RS-02-013

Clinton Power Station, Unit 1
Facility Operating License No. NPF-62
NRC Docket No. 50-461

Subject: Response to Request for Additional Information Regarding Risk Aspects
of Inclined Fuel Transfer System License Amendment Request for Clinton
Power Station

FIGURE 1

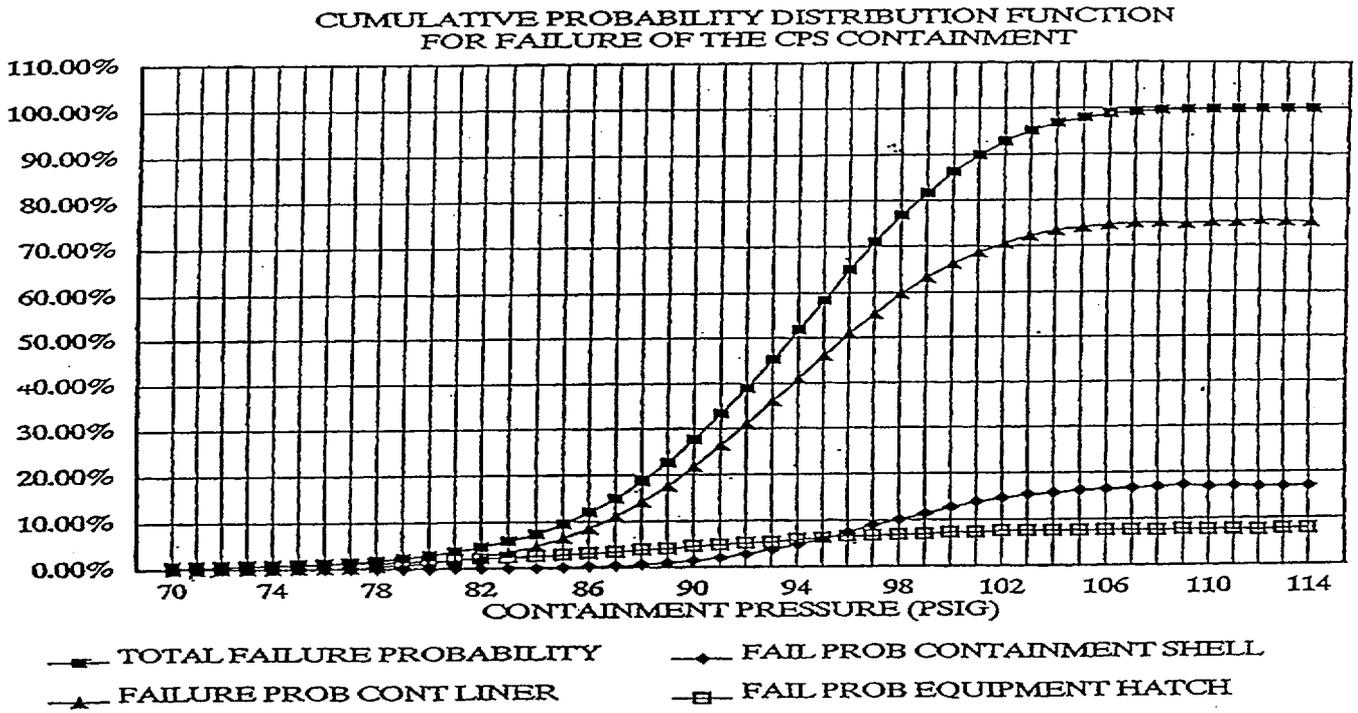
- b. *the fragility curves (probability of failure as a function of containment pressure) for the major containment structures and penetrations (including the drywell, containment cylinder and dome, personnel airlocks, equipment hatches, and IFTS),*

- b. Containment fragility curves were developed to estimate the containment failure probability as a function of containment pressure due to a number of potential containment failure mechanisms. These fragility curves are shown in Figure 1. The fragility curves do not include a failure mechanism for the drywell because the drywell is enclosed by the containment and because the drywell vent arrangement will limit the differential pressure across the drywell below pressures at which it would fail. The fragility curves do not include a failure estimate for the IFTS system either because, with the IFTS piping and IFTS flange rotated to the closed position, the pressure retaining capacity remains well within the capability of the other containment structures.
